Access Compliance Report Public Rights-of-Way (Pedestrian Signals)

Intersection ID: N/A	Main Street:	Cross Street: N/A	Location: N/A
ADA ID: D7B95950137D	Signal Type: One Push Button-Non APS	Overall Compliance: No	Severity Score: BTN 1: N/A BTN 2: N/A No BTN: N/A
Codes/Mitigation Info/Possible Solution		Field Measurements/Component Compliance

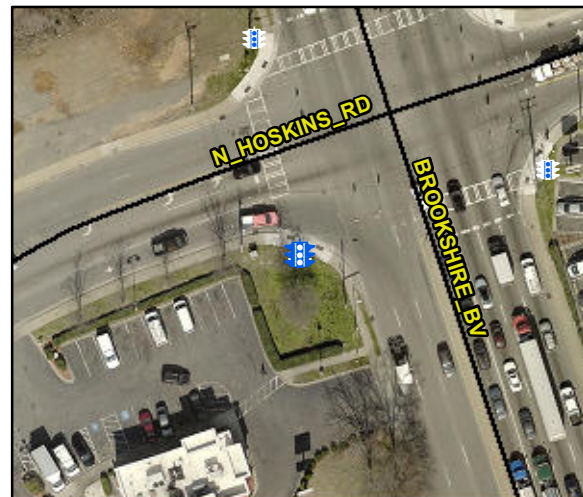
Surveyor Notes: TX HT 1/4

PROW/ADA: R410.6, TMUTCD 4e.08, R404.2, R404.3, R406.2, R404.7.3

Compliance	Description	Data	Compliance	Description	Data
	Button Count	Button1	N/A	Distant to Additional Button (in)	N/A
	Additional Button Present?	No		Additional Button ID	N/A
N/A	Signal Buttons Required?	N/A	N/A	Additional Ped Posts Required	N/A
	How Many Ped Street Xings?	2.0		Located In An Island/Median?	No
N/A	B 1 Sign Present?	Yes	N/A	B 2 Sign Present?	N/A
Yes	B 1 Sign Purpose?	Yes	N/A	B 2 Sign Purpose?	N/A
No	B 1 Sign Lettering & Contrast?	No	N/A	B 2 Sign Lettering & Contrast?	N/A
Yes	B 1 Parallel To XWalk?	Yes	N/A	B 2 Parallel To XWalk?	N/A
Yes	B 1 PAR to Button?	Yes	N/A	B 2 PAR to Button?	N/A
Yes	B 1 PAR to XWalk?	Yes	N/A	B 2 PAR to XWalk?	N/A
Yes	B 1 Clear Floor Space?	Yes	N/A	B 2 Clear Floor Space?	N/A
N/A	B 1 FWD Approach?	Yes	N/A	B 2 FWD Approach?	N/A
N/A	B 1 FWD Approach Constrained?	No	N/A	B 2 FWD Approach Constrained?	N/A
No	B 1 FWD Approach Reach (in)	21.0	N/A	B 2 FWD Approach Reach (in)	N/A

N/A	B 1 FWD Approach Width (in)	N/A	N/A	B 2 FWD Approach Width (in)	N/A
N/A	B 1 FWD Approach Obstruction?	Yes	N/A	B 2 FWD Approach Obstruction?	N/A
N/A	B 1 FWD Approach Obstruction Dist (in)	21.0	N/A	B 2 FWD Approach ObstructionDist (in)	N/A
N/A	B 1 PARA Approach?	Yes	N/A	B 2 PARA Approach?	N/A
N/A	B 1 PARA Approach Constrained?	No	N/A	B 2 PARA Approach Constrained?	N/A
No	B 1 PARA Approach Reach (in)	20.0	N/A	B 2 PARA Approach Reach (in)	N/A
N/A	B 1 PARA Approach Width (in)	N/A	N/A	B 2 PARA Approach Width (in)	N/A
N/A	B 1 PARA Approach Obstruction?	Yes	N/A	B 2 PARA Approach Obstruction?	N/A
N/A	B 1 PARA Approach Obstruction Dist (in)	20.0	N/A	B 2 PARA Approach ObstructionDist (in)	N/A
No	B 1 Clear Floor Space Slope (%)	6.6	N/A	B 2 Clear Floor Space Slope (%)	N/A
Yes	B 1 Clear Floor Space XSlope (%)	1.6	N/A	B 2 Clear Floor Space XSlope (%)	N/A
N/A	B 1 PAR Slope (%)	1.6	N/A	B 2 PAR Slope (%)	N/A
Yes	B 1 Height (in)	35.0	N/A	B 2 Height (in)	N/A

Yes	B 1 Clear Xing Direction?	ClearlyMarked	N/A	B 2 Clear Xing Direction?	N/A
	B 1 Crossing Direction	To E		B 2 Crossing Direction	N/A
Yes	B 1 DistanceTo XWalk (in)	0.0	N/A	B 2 DistanceTo XWalk (in)	N/A
No	B 1 DistanceTo Curb (in)	127.0	N/A	B 2 DistanceTo Curb (in)	N/A
Yes	B 1 Diameter (in)	2.0	N/A	B 2 Diameter (in)	N/A

Possible Solutions: Replace Signal Push Button With APS Button on New Post. Remove & Replace Sign.
